REVISION B CONSULTANT

MD 45 (YORK ROAD) AT TIMONIUM ROAD

SIGNAL PLAN

DRAWING NO. 510 C TS-03 OF 04 — SHEET NO. 13 OF 14

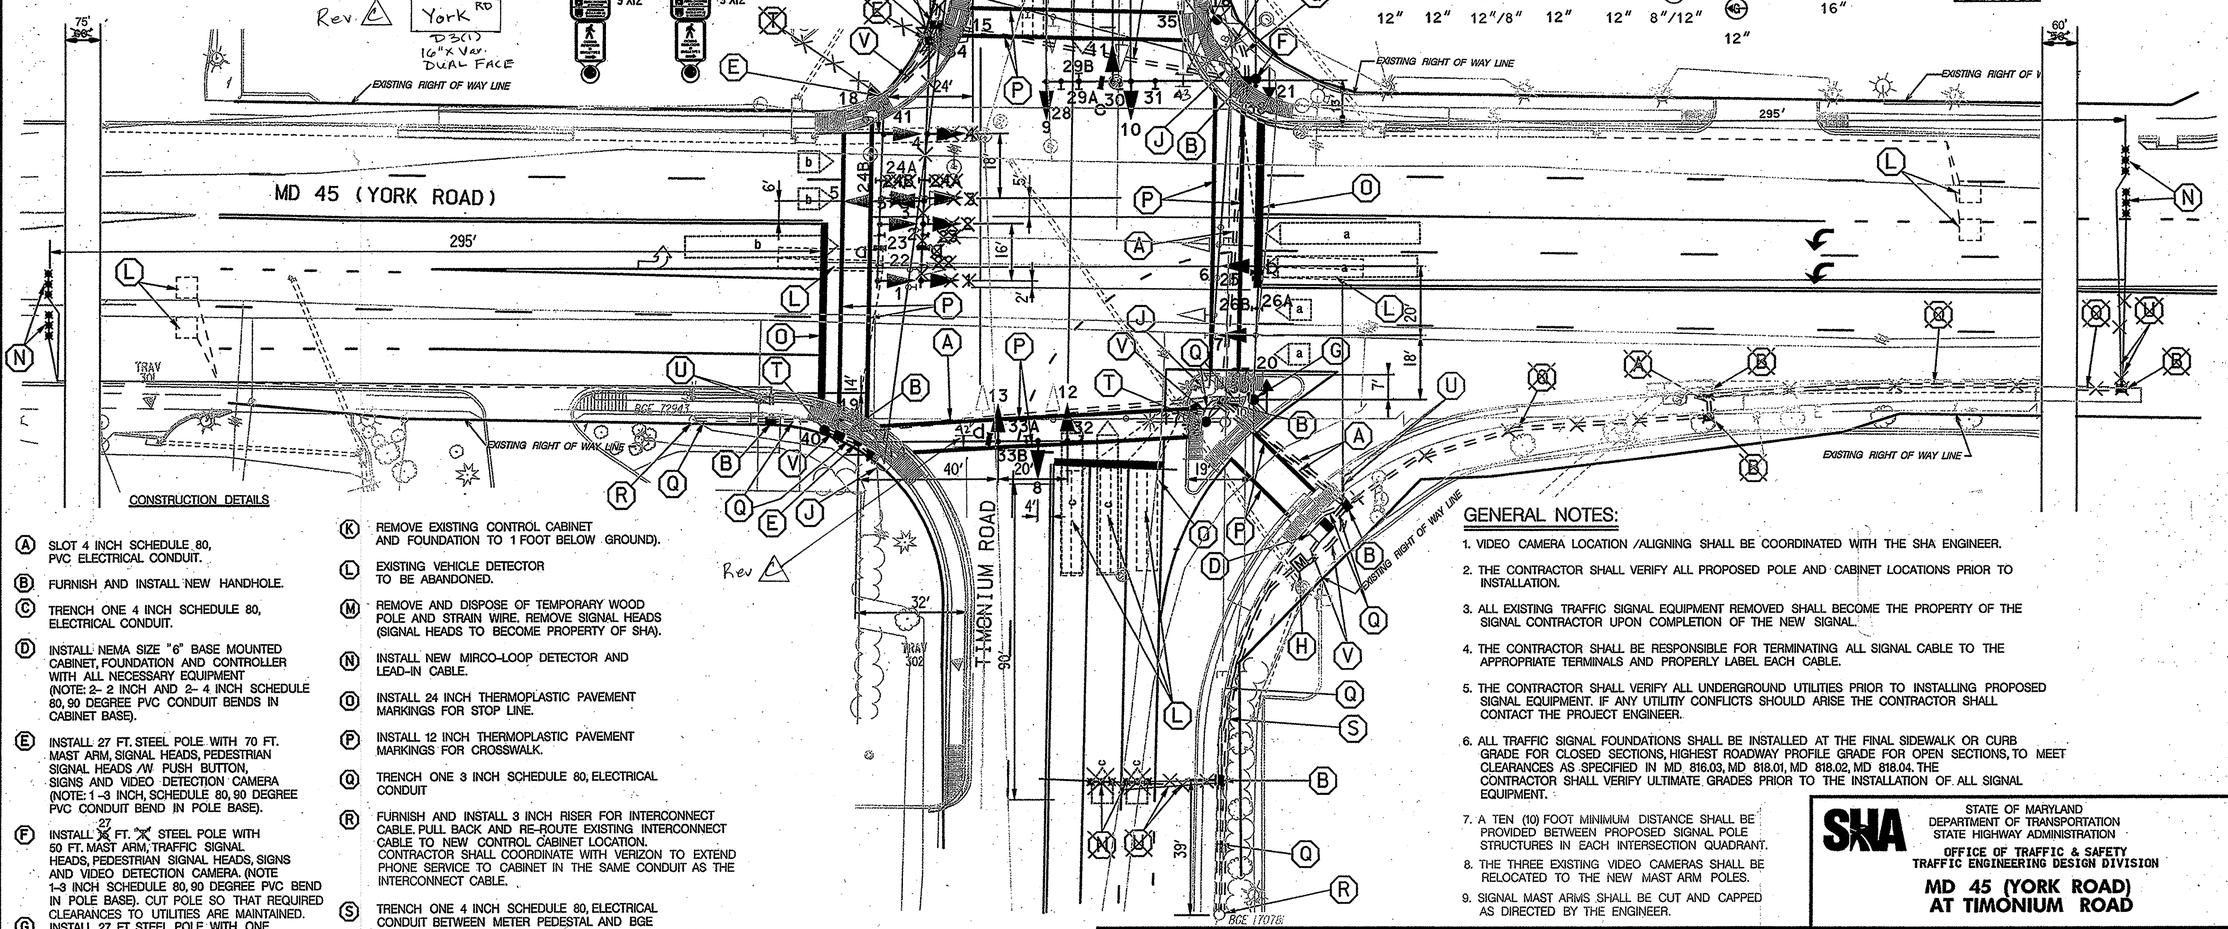
GREEN LINE - RELOCATED MICROPROBE LEAD-IN CABLES AND REVISED LOCATIONS OF SIGNAL POLE AND PEDESTRIAN POLE IN THE NORTHEAST QUADRANT OF THE INTERSECTION

REVISIONS
B SIGNAL MODIFICATIONS — BA4945187
MA/FAE — B — 9-21-98 — Install "York Rd" Street name signs SF-Signal — JSD
